## ADDENDUM NO. 2

Date: August 26, 2025  
Project: **Phase 2: Foundation Installation (Multipurpose Laboratory Building)**  
Job No.: 24600-01

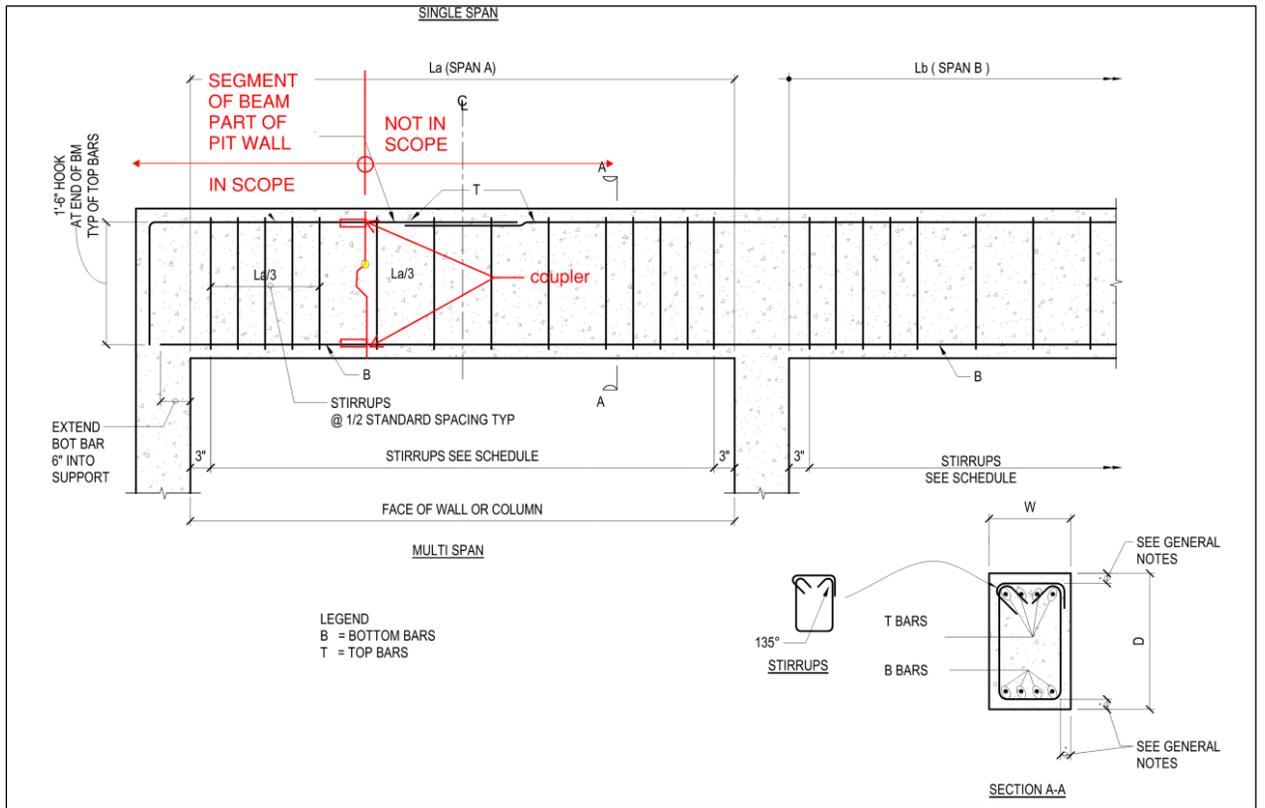
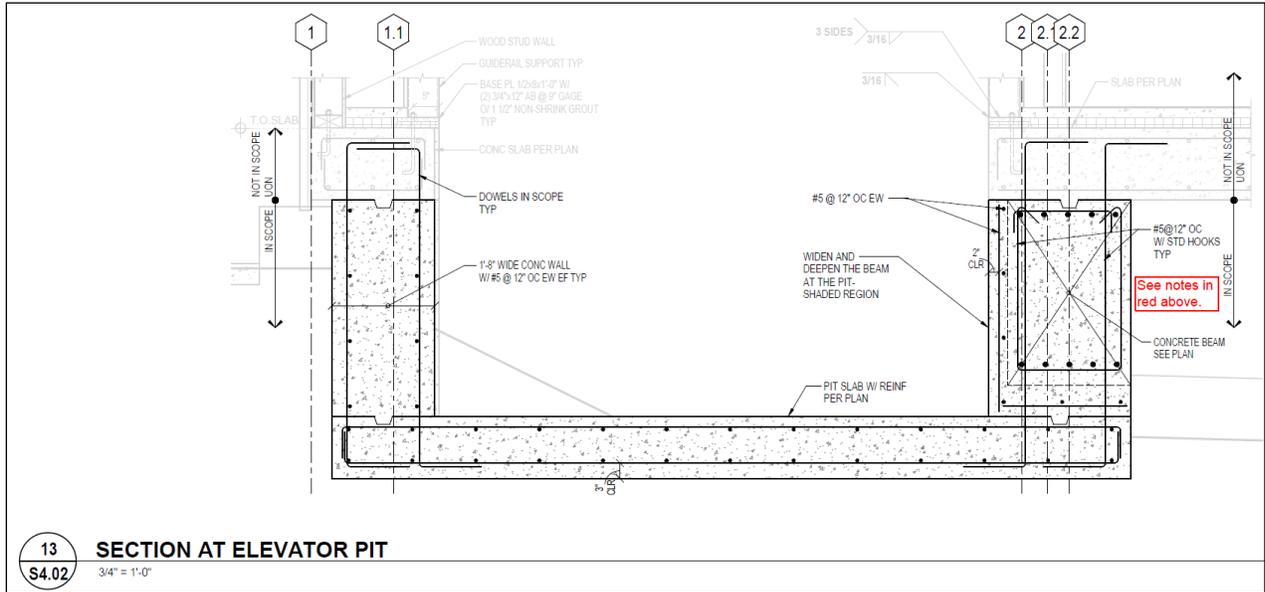
Q13. Rebar. It appears the rebar in PH2 is standard grade 60. Concrete note #4 on S0.01 mentions 80 ksi rebar for concrete beams at suspended slab. I don't see those beams depicted in the PH2 scope. Is 80 ksi rebar required in PH2? If so please provide all of the locations of these beams.

- a. All foundation elements in Phase 2 (piers, grade beams, pier caps) require 60 ksi rebar except for the concrete beam CB3 for the elevator pit wall highlighted in red below, which requires 80 ksi rebar.
- b. See note in red below and 1/S4.04 from the Project structural engineer regarding installation of rebar couplers for the elevator pit rebars to provide continuity of beam reinforcing for the Phase 3 project.
- c. Except portions of CB3 shown in 13/S4.02 and 1/S4.04 below, all concrete beams designated as CB# and suspended slab are not part of the Phase 2 contract and will be included in the upcoming Phase 3 project.
